**SOLICITATION AMENDMENT
MODIFICATION DE L'INVITATION**

Title - Sujet Meubles de bureau MDN	
Solicitation No. - N° de l'invitation EB129-211701/B	Amendment No. - N° modif. 001
Client Reference No. - N° de référence du client EB129-211701	Date 2021-02-12
GETS Reference No. - N° de référence de SEAG PW-\$XAQ-027-7561	
File No. - N° de dossier XAQ-0-43122 (027)	CCC No./N° CCC - FMS No./N° VME
Solicitation Closes - L'invitation prend fin at - à 02:00 PM Newfoundland Standard Time NST on - le 2021-03-02 Heure Normale de Terre-Neuve HNT	
F.O.B. - F.A.B. Plant-Usine: <input type="checkbox"/> Destination: <input checked="" type="checkbox"/> Other-Autre: <input type="checkbox"/>	
Address Enquiries to: - Adresser toutes questions à: Walsh, Heather	Buyer Id - Id de l'acheteur xaq027
Telephone No. - N° de téléphone (709) 631-1853 ()	FAX No. - N° de FAX (709) 772-4603
Destination - of Goods, Services, and Construction: Destination - des biens, services et construction: Department of National Defence 84-86 Elizabeth Avenue, Regatta Plaza II, St. John's, NL A1B2E6

MODIFICATION N° 001 À L'INVITATION

OND Elec.pdf

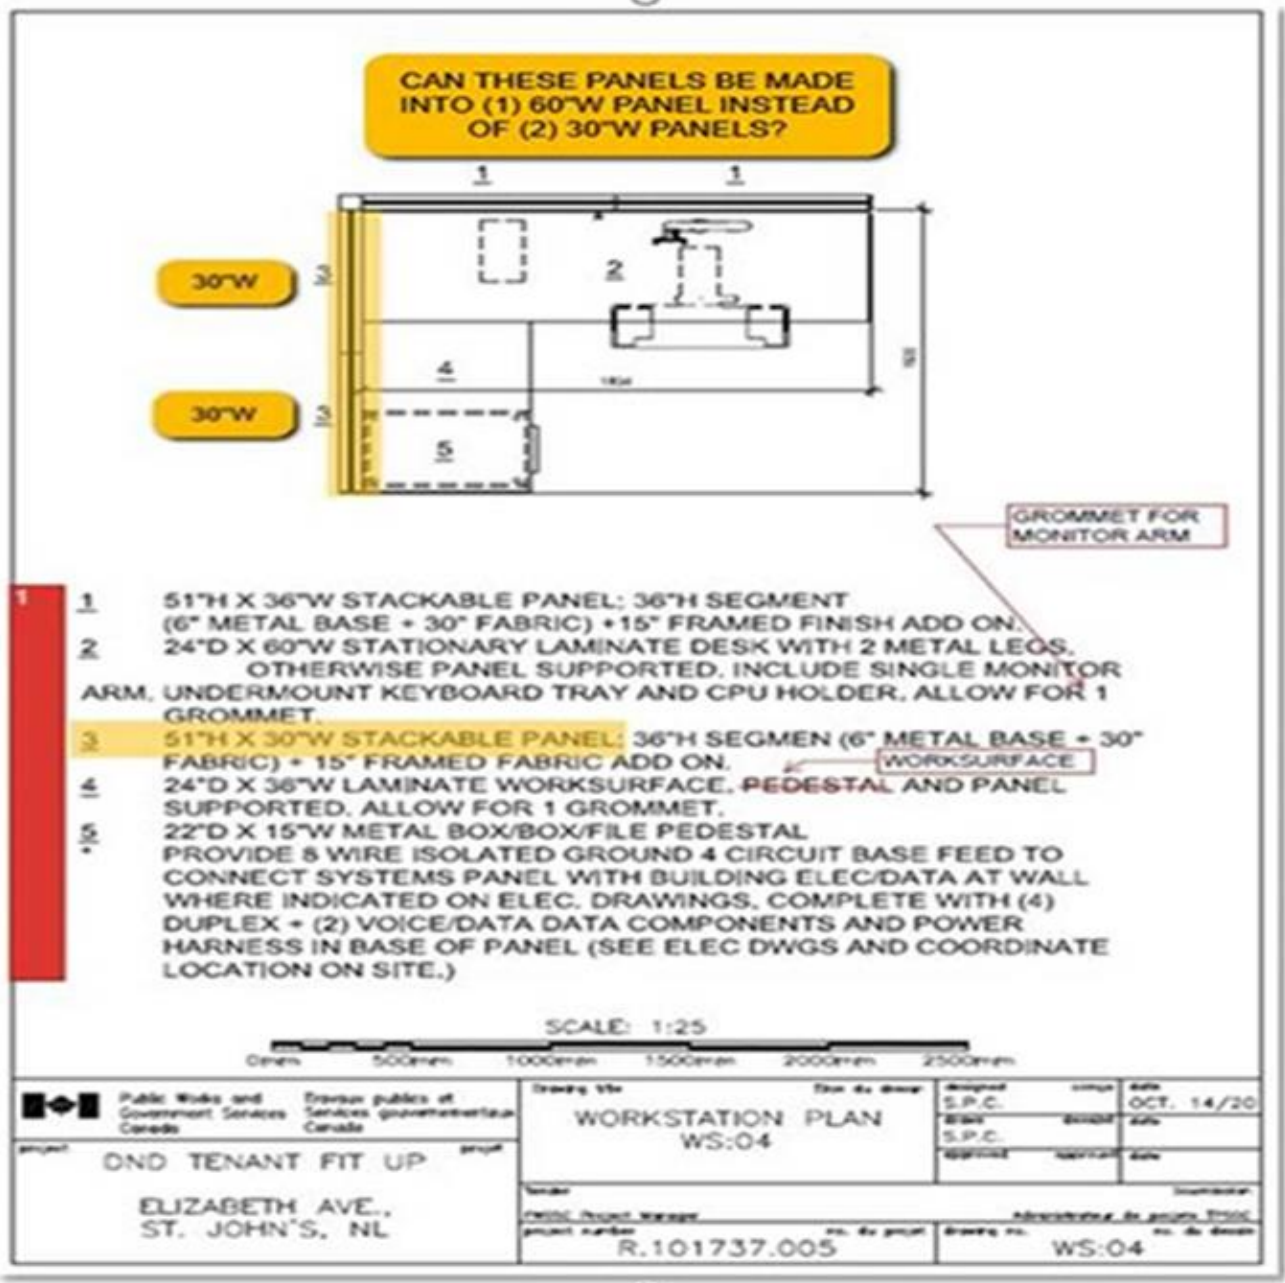
Q12. I see the data locations in each station on the electrical plan, but not duplex/triplex locations. You want 4 duplexes (8 plugs total) per station, would 3 triplexes be acceptable (9 plugs total).

Powered panels are not indicated on the plan (floor plan, or typical details), am I to assume we can power them at our discretion?

- PSPC Response: The issue for construction electrical drawing is attached for reference. 3 triplexes is be acceptable.
- Réponse du SPAC : La question pour les travaux de construction dessin électrique est jointe pour renvoi 3 triplex est acceptable.
